STATE OF NORTH CAROLINA
DEPARTMENT OF TRANSPORTATION

Subject: **Response to NCDWR Hold Letter and Revised Application for Section 404 Nationwide Permit 14 and Section 401 Water Quality Certification** for the proposed US 21 Improvements from SR 1100 (Old Gap Rd) in Roaring Gap to SR 1121 (Pine Swamp Rd) in Sparta, Alleghany County, Federal Aid Project No. STP-21(11); Division 11; TIP No. R-3101; \$570.00 debit WBS No. 37044.1.1

Reference: NCDOT Nationwide 14 Permit Application dated July 24, 2013
NC Division of Water Resources "On Hold" Letter dated August 6, 2013

STANDARD BASE DITCH
 -L- STA. 139+62 LT
 DDE = 8 CY
 SEE DETAIL 4

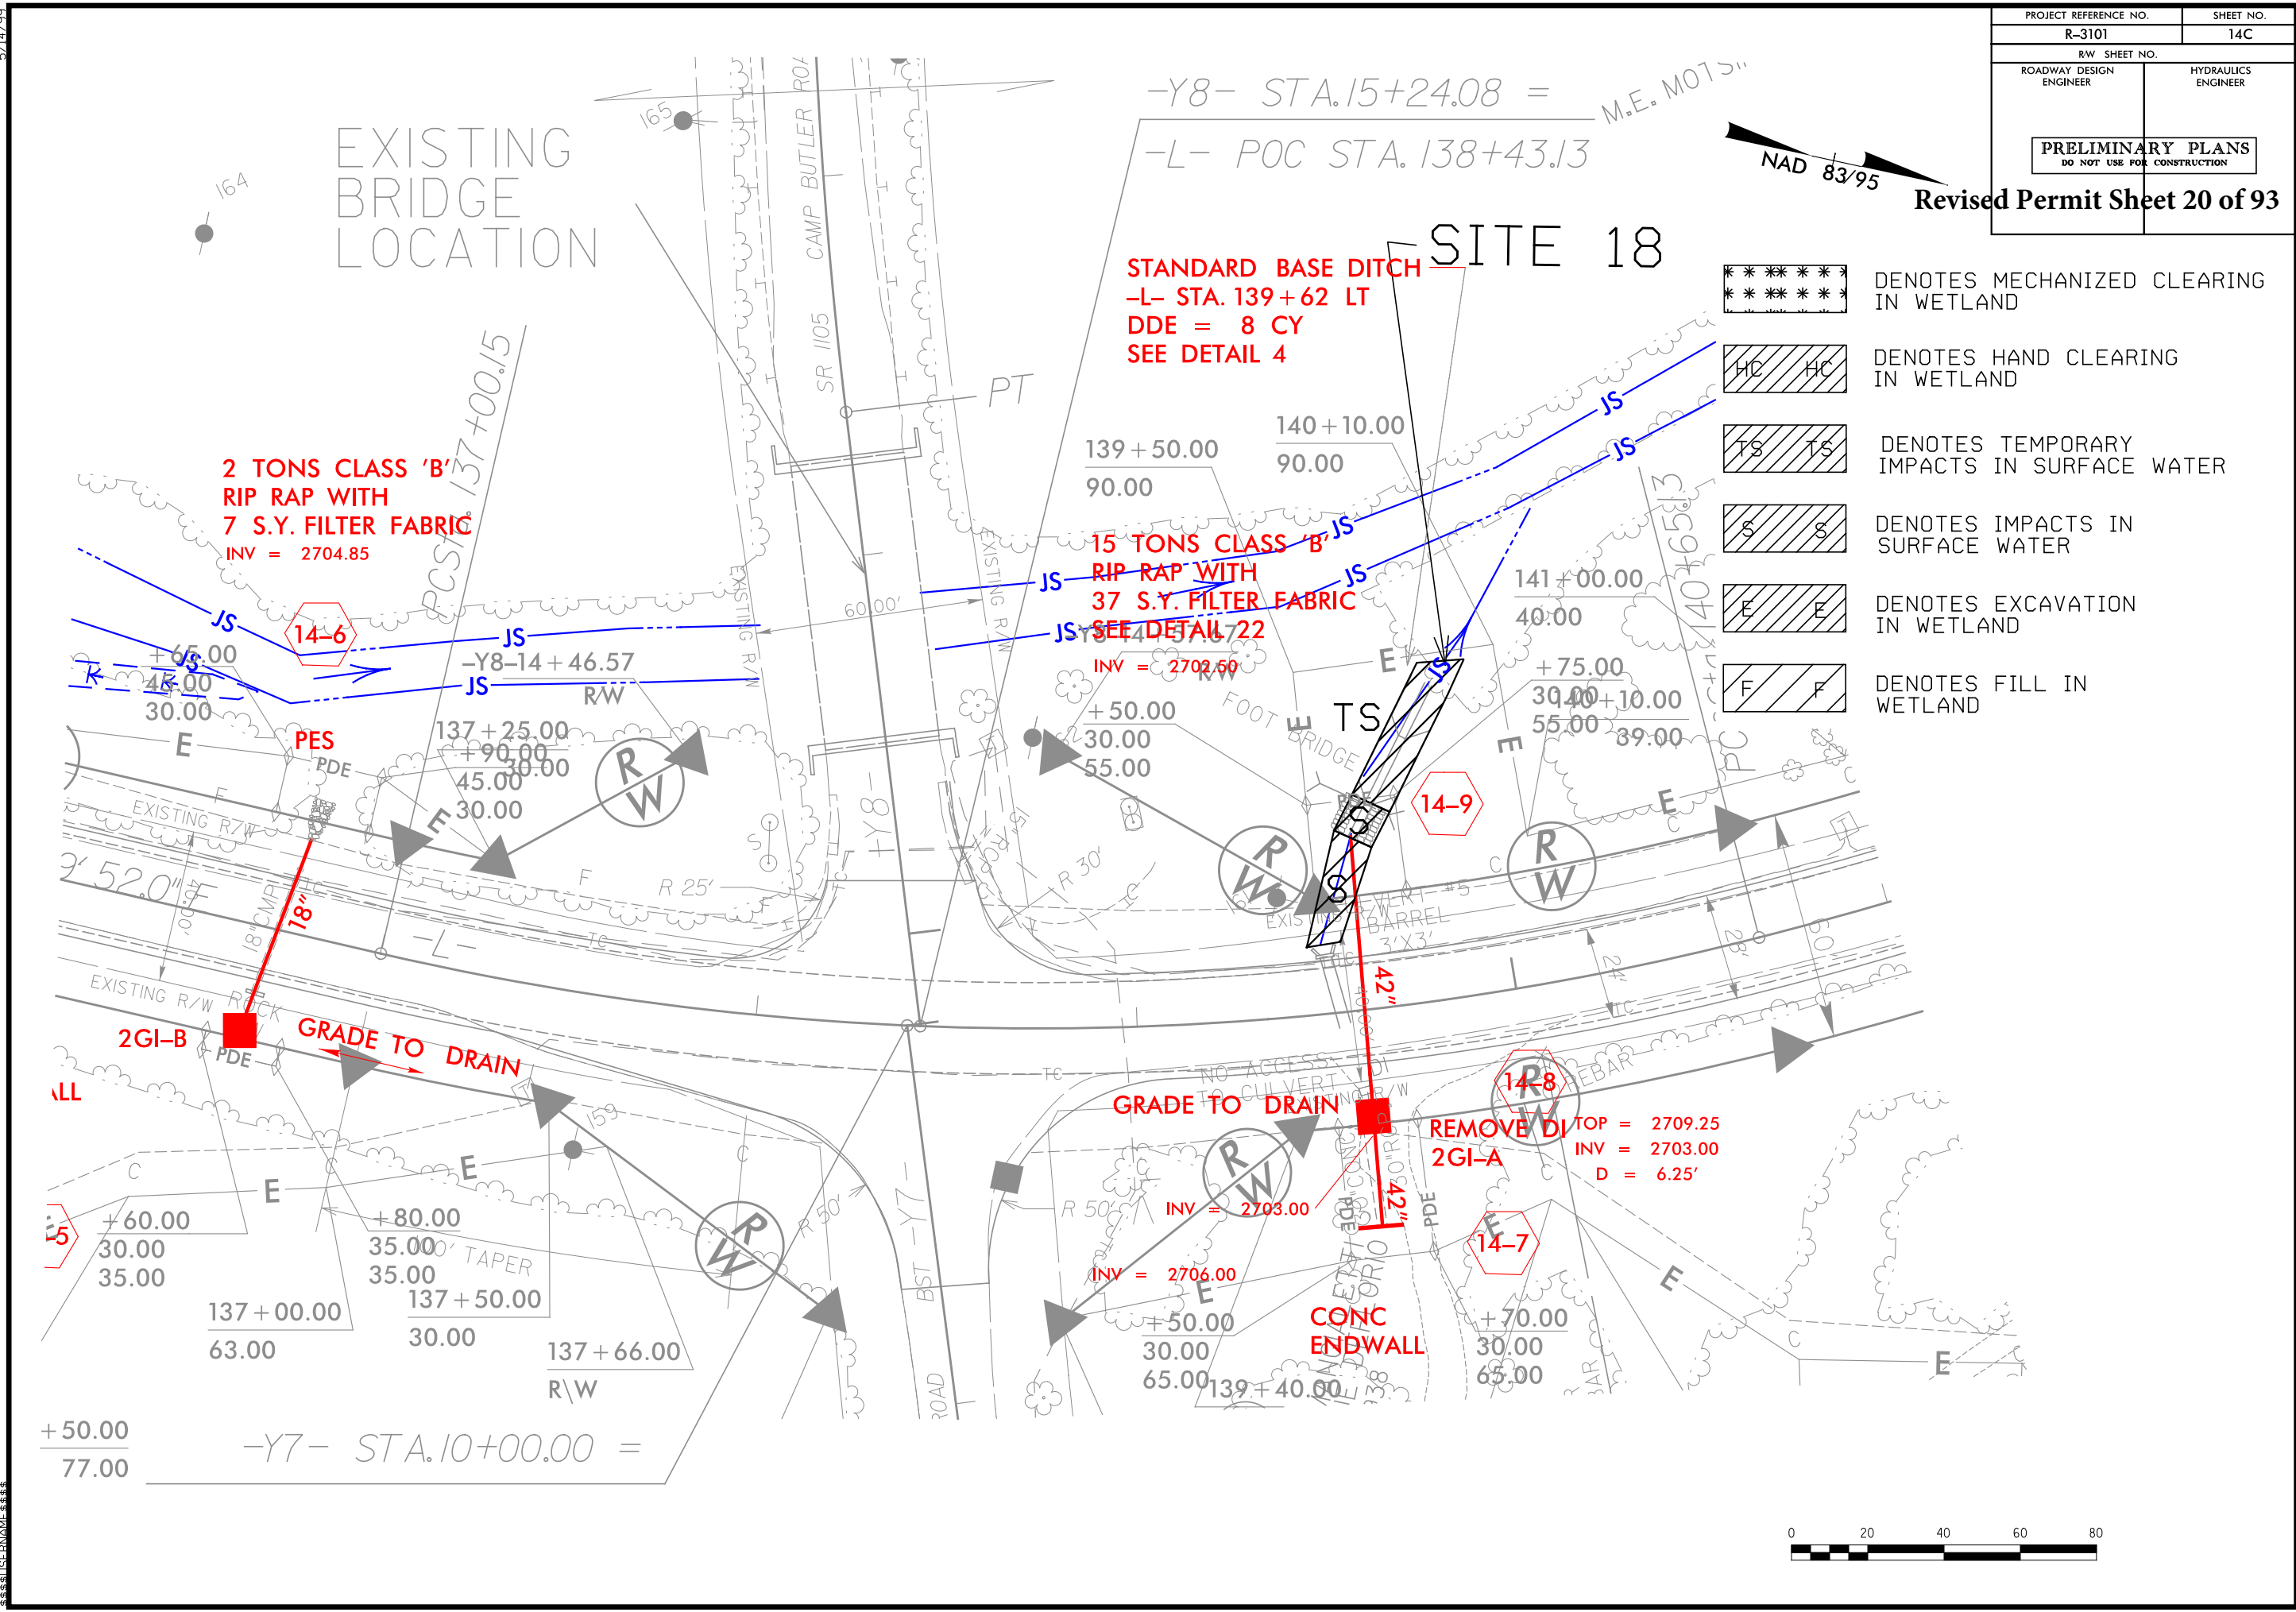
11. Site 18: The impact table shows bank stabilization, however, the detail for the channel (detail 4) doesn't show any rock. If you are sloping the banks back, its typically not considered a permanent bank stabilization impact.
NCDOT Response: Site 18 has been revised on the permit drawings to depict the bank stabilization at the pipe outfall. The stream work beyond the bank stabilization is captured in Detail 4.

Revised Permit Sheet 26 of 93

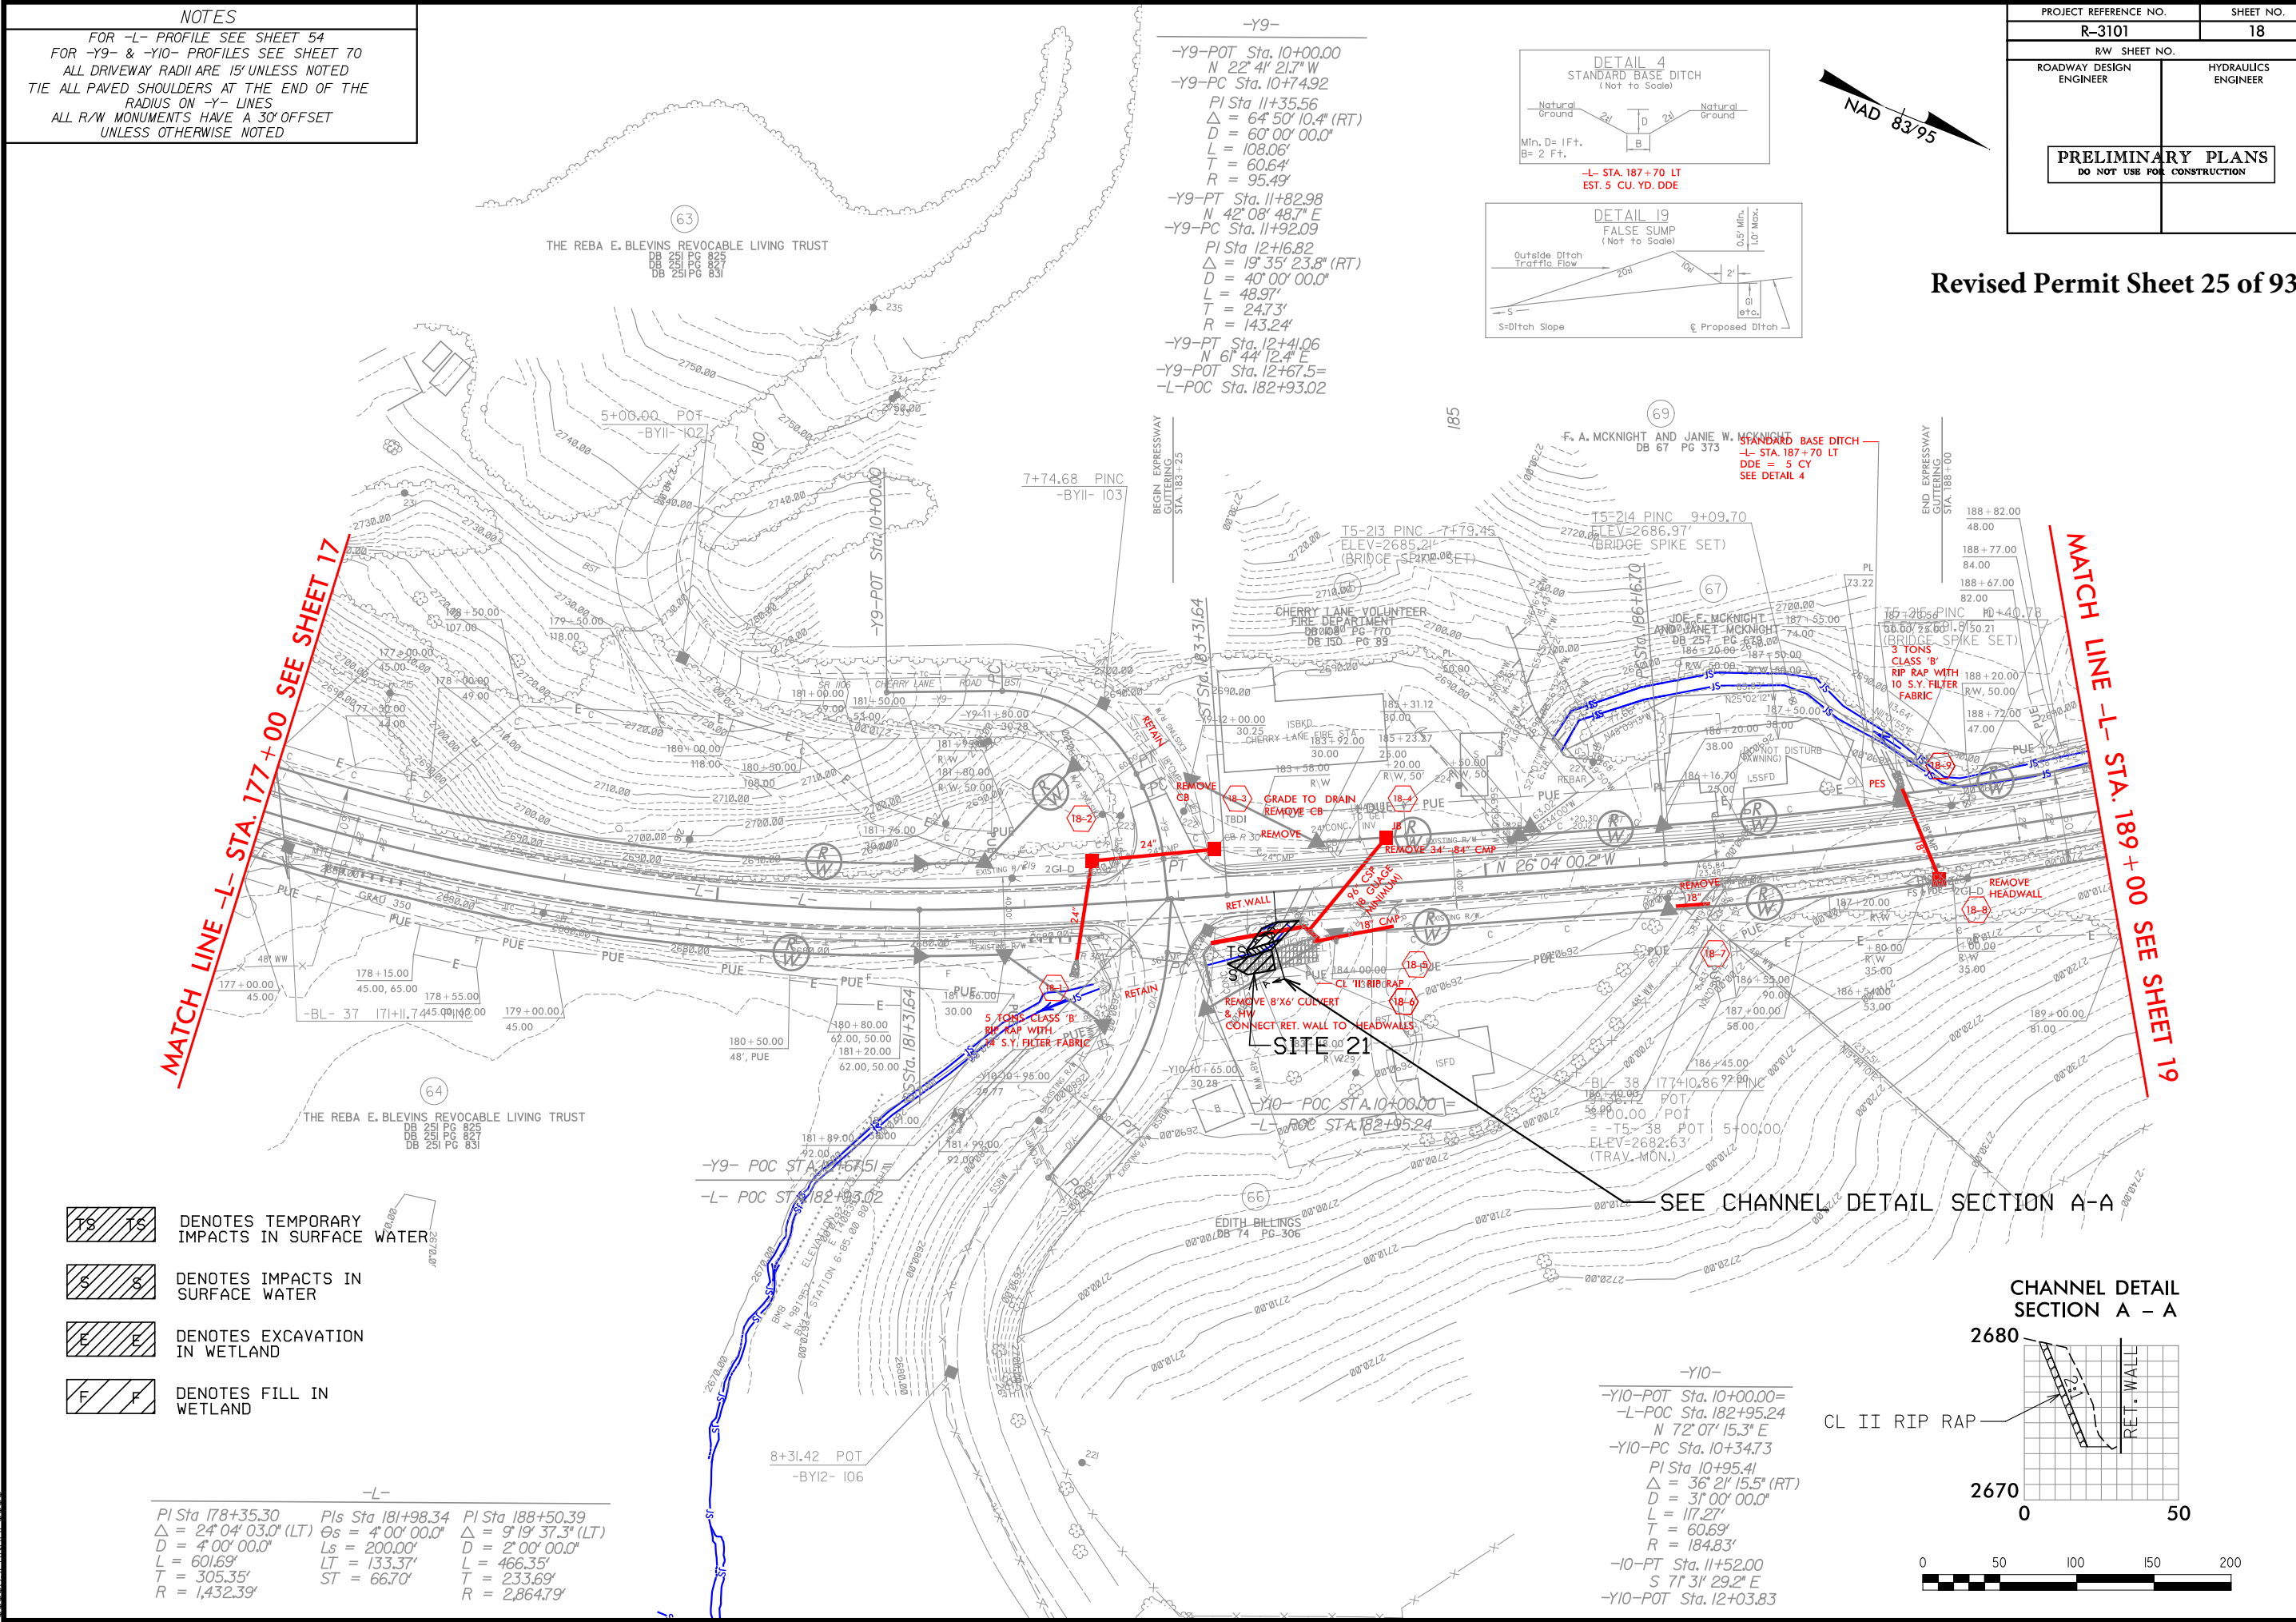
13. Site 21: Need channel detail for the relocated portion of the stream.
NCDOT Response: "Channel Detail Section A-A" has been included for Site 21 on Sheet 18.

SITE 43

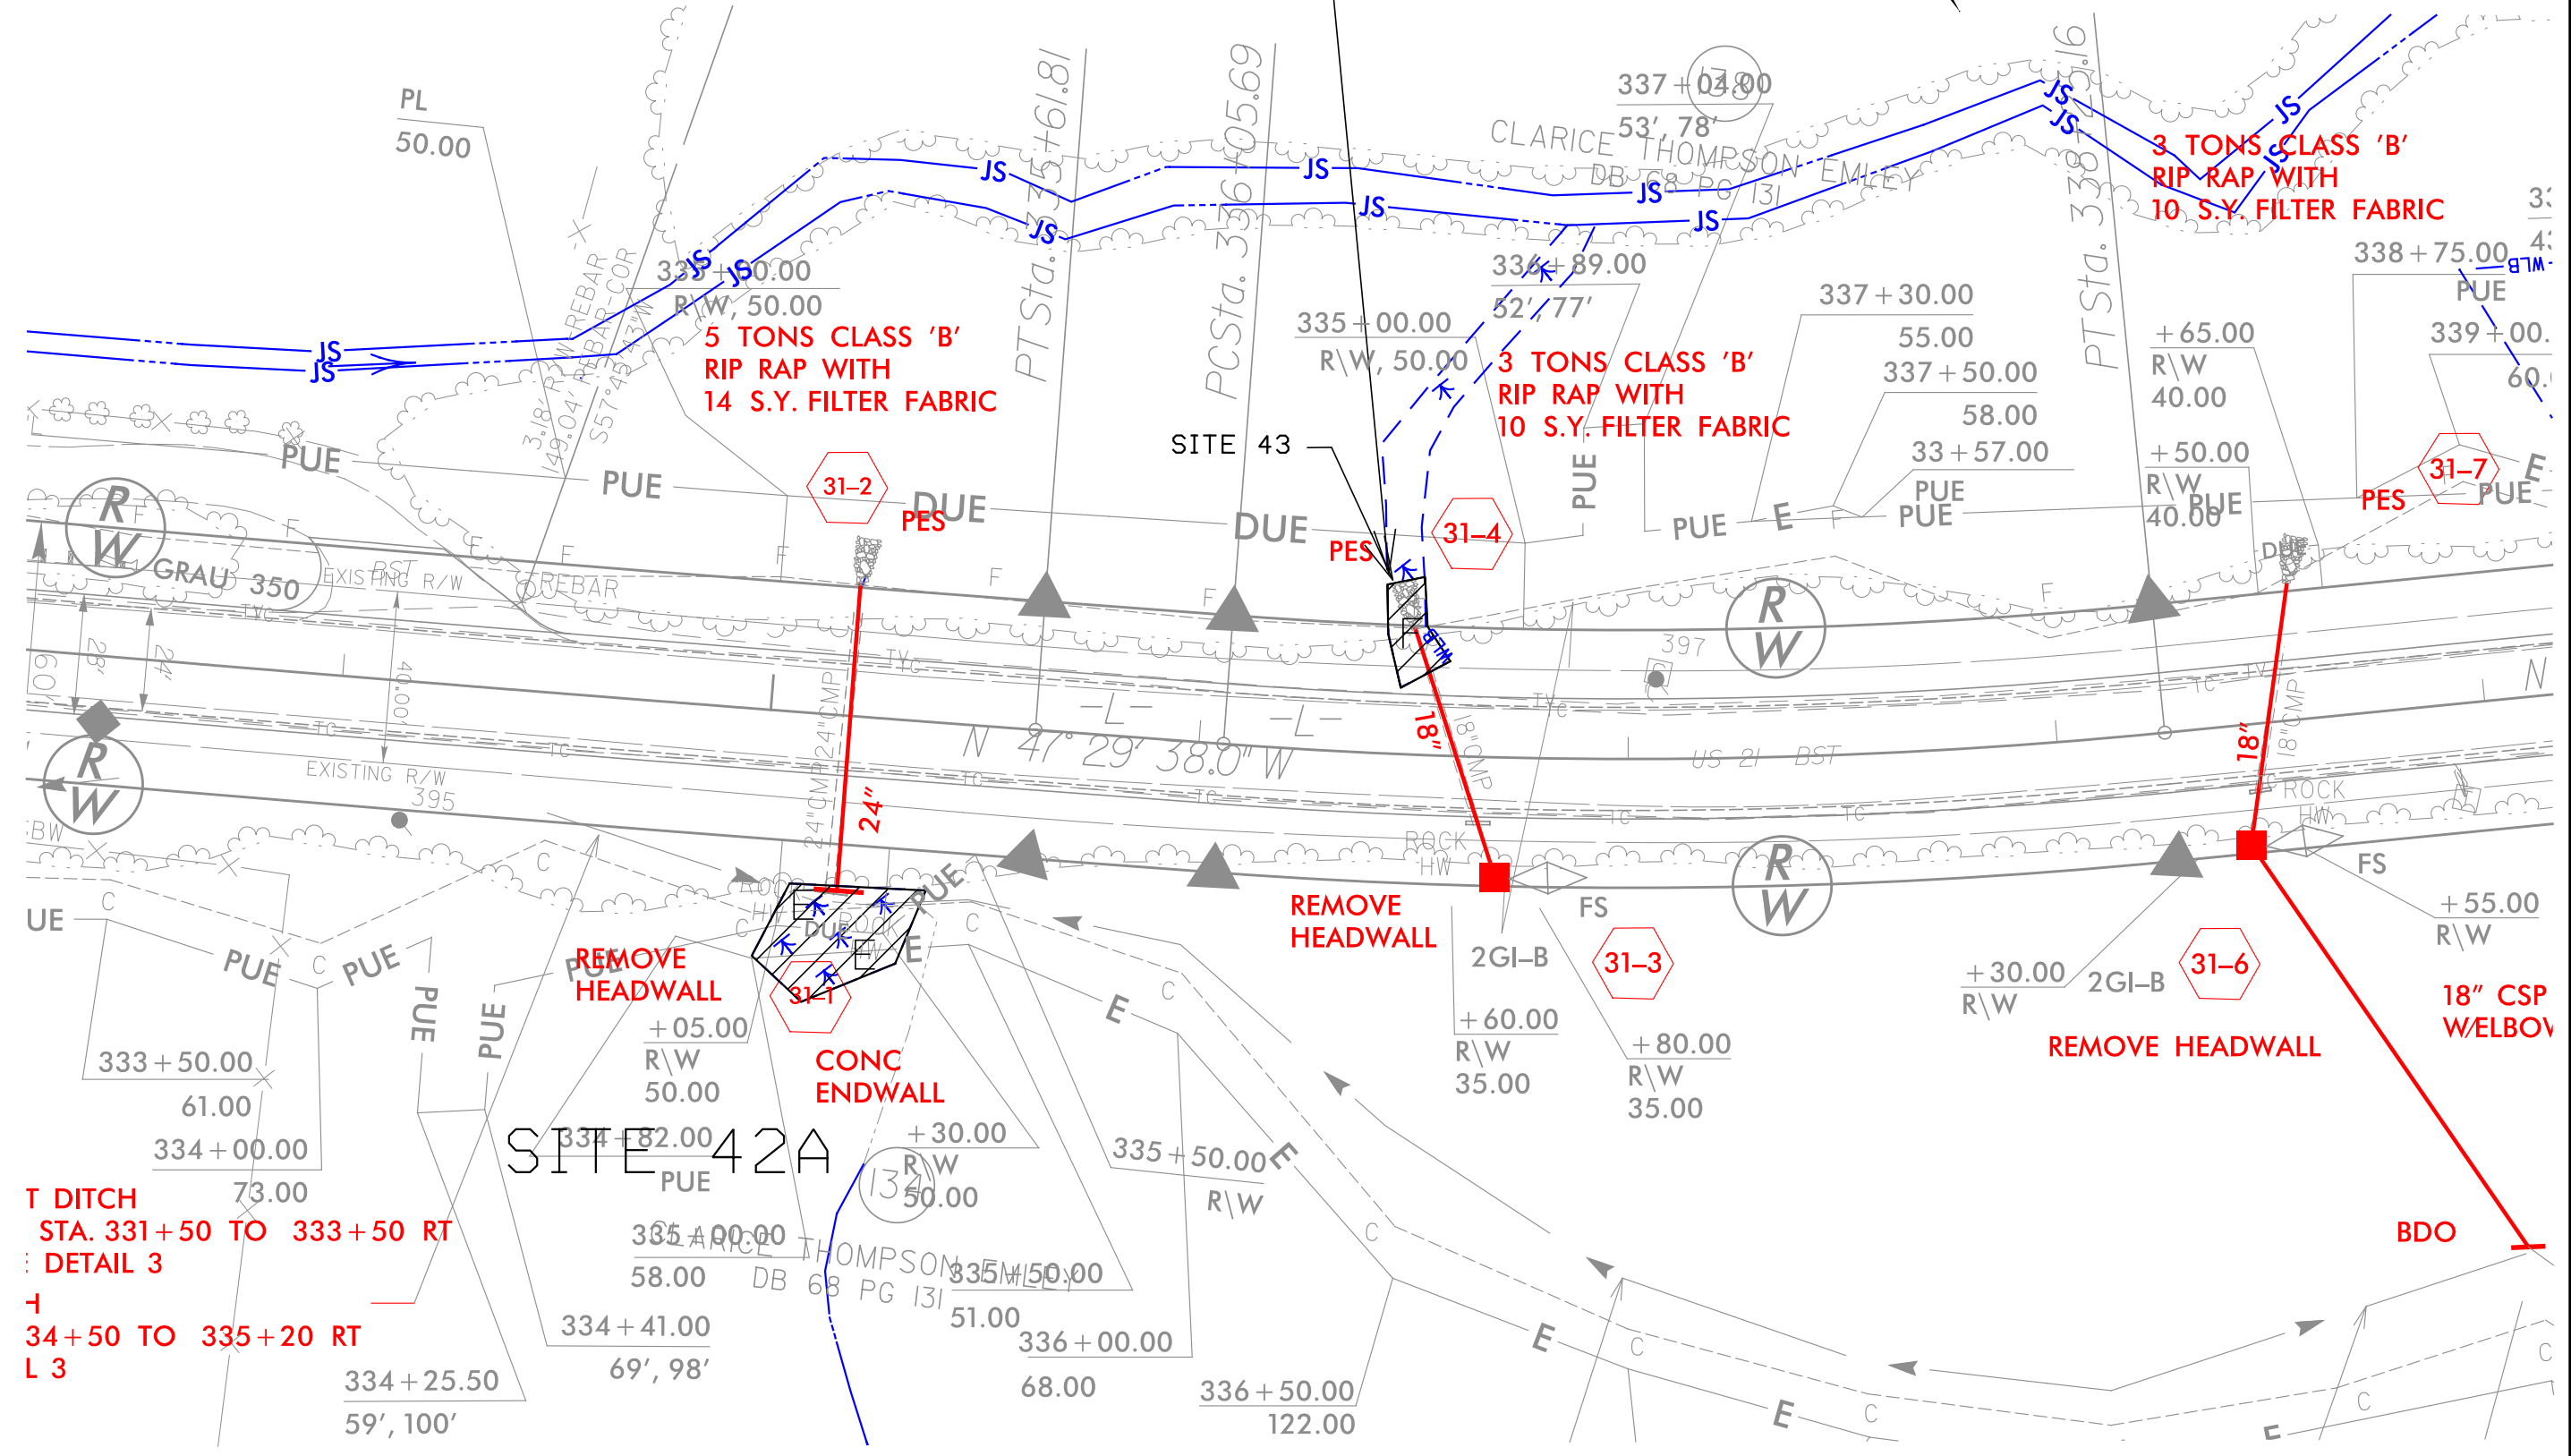
9. There are blue lines on the plans that aren't listed as JS. These are adjacent to sites 14, 19, adjacent to station 153 (sheet 15), and both sides of site 43.
NCDOT Response: These sites have been assessed and determined not jurisdictional. Supporting information was provided to the Agencies on September 5, 2013.
